Submission of Further Information (FI)

**Temporary Place of Recreation, Sports or Culture and Animal Boarding
Establishment with Ancillary Facilities and Associated Filling of Land and Pond
for a Period of 3 Years in "Agriculture" Zone, Lots 1464 (Part), 1466 (Part), 1486 (Part),
1489 (Part) and 1494 (Part) in D.D. 107 and Adjoining Government Land,
Kam Tin, Yuen Long, New Territories
(Application No. A/YL-KTN/1164)**

Further Information for Planning Application No. A/YL-KTN/1164**Response-to-Comments****Comments from Planning Department**

Plan 6a
(P 22034)

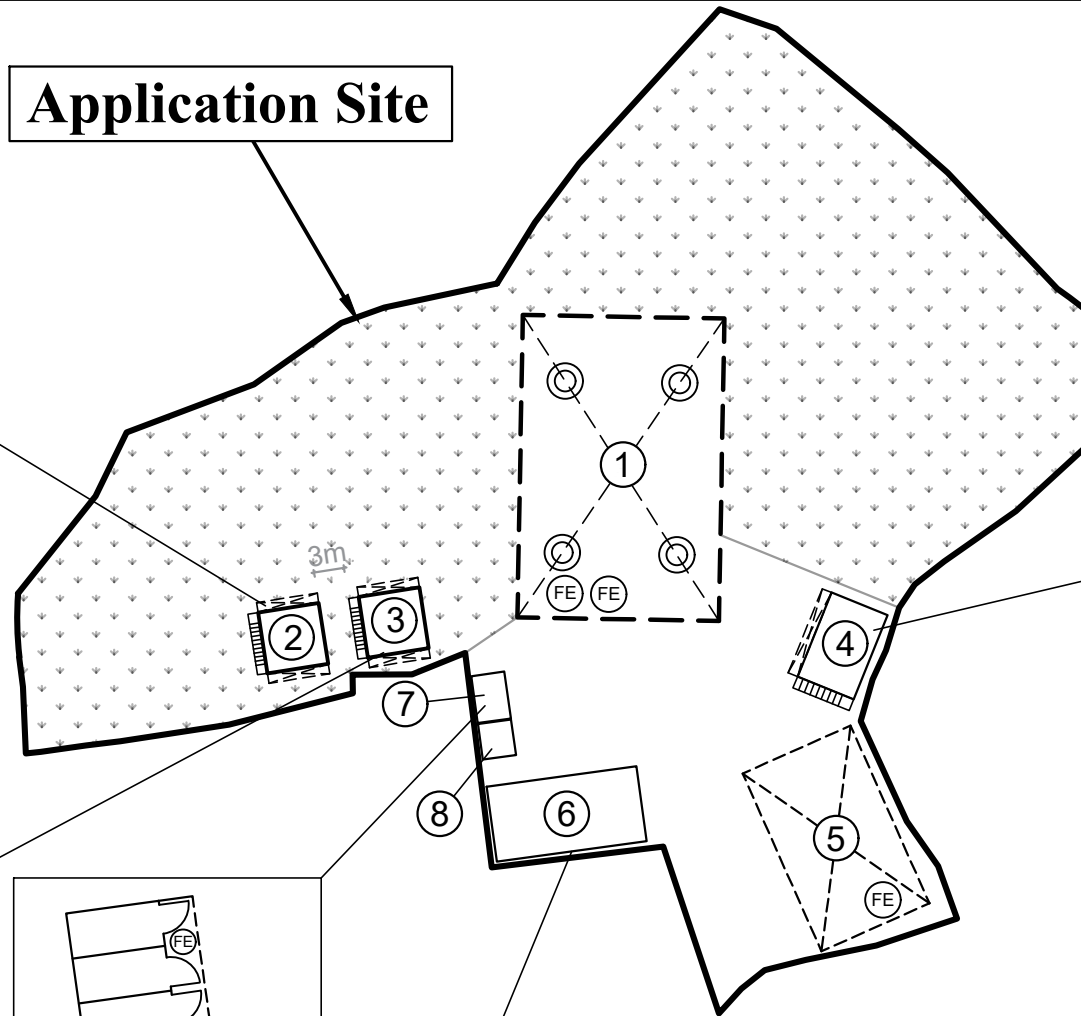
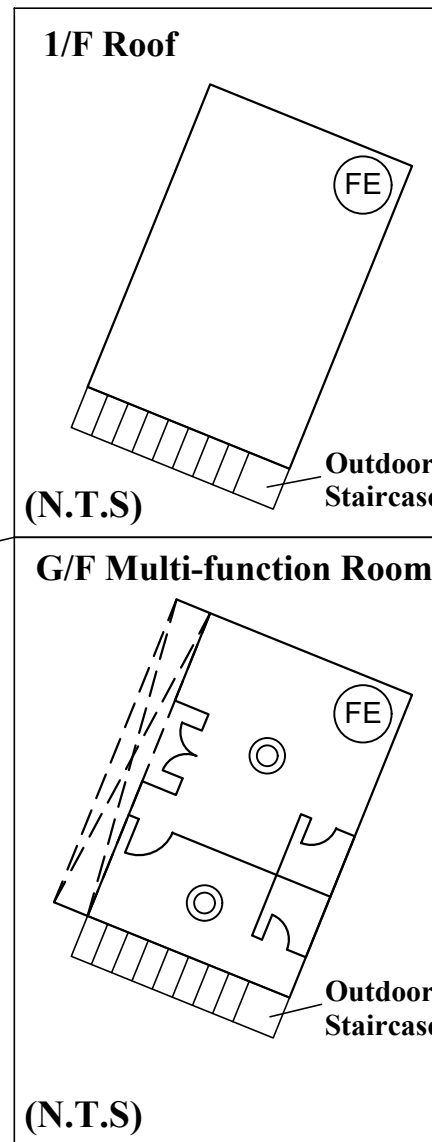
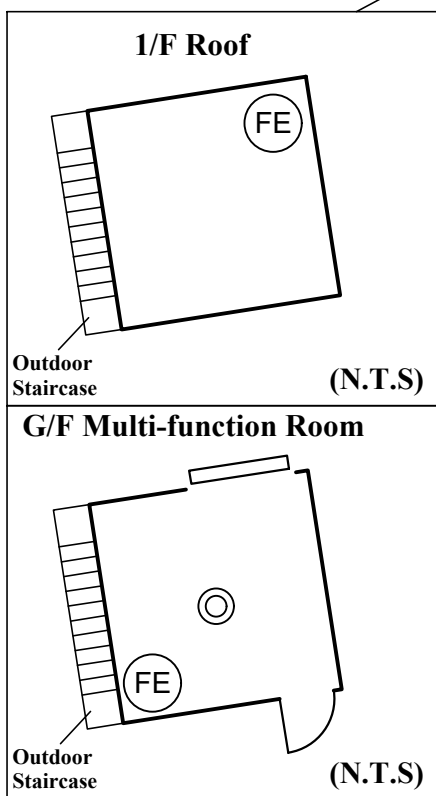
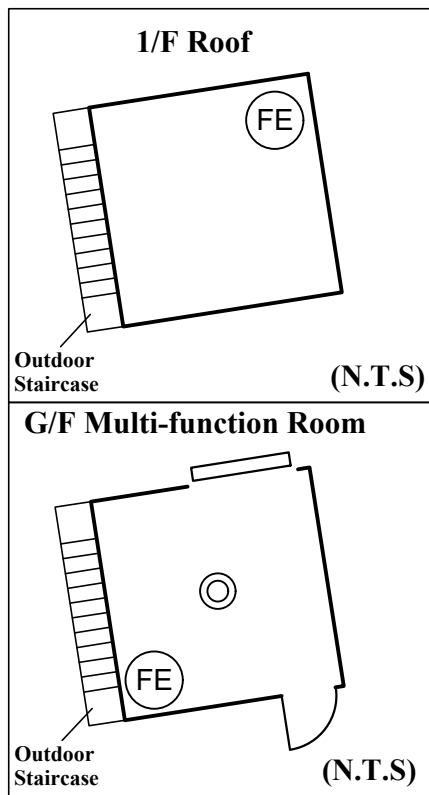
III.	Comments	Responses
1.	<p>i. For enclosed structure with gross floor area not exceeding 230m², only fire extinguisher and Stand-alone Fire Detector shall be provided;</p> <p>ii. In relation to i. above, where two or more Stand-alone Fire Detectors are installed in an enclosed structure, all stand-alone detectors shall be interconnected (either wired or wirelessly) such that when one of the stand-alone fire detector is triggered, all connected Stand-alone Fire Detectors shall sound an alarm simultaneously;</p> <p>iii. The Stand-alone Fire Detector shall be provided in accordance with the “Stand-alone Fire</p>	Please refer to the revised FSI proposal (Plan 6a) for details.

<p>Detector General Guidelines on Purchase, Installation & Maintenance [Sep 2021]”;</p> <p>iv. Modified hose reel system, fire alarm system, emergency lighting, directional and exit signs are considered as self-upgrade and not a mandatory requirement by this Department.</p> <p>v. If the applicant self-initiates the provision of directional and exit signs, the standards and specification shall be in accordance with “BS 5266-1:2016 and the FSD Circular Letter No. 5/2008”; and</p> <p>vi. If the applicant self-initiates the provision of modified hose reel system, the standards and specification shall be in accordance with “Code of Practice for Minimum Fire Service Installations and Equipment 2022”;</p>

2.	Please advise the applicant to clarify whether the 1/F of Structures 2, 3 and 4 is a covered area. If yes, Stand-alone Fire Detectors shall be provided.	1/F of structures 2, 3 and 4 is a rooftop and it is not a covered area.
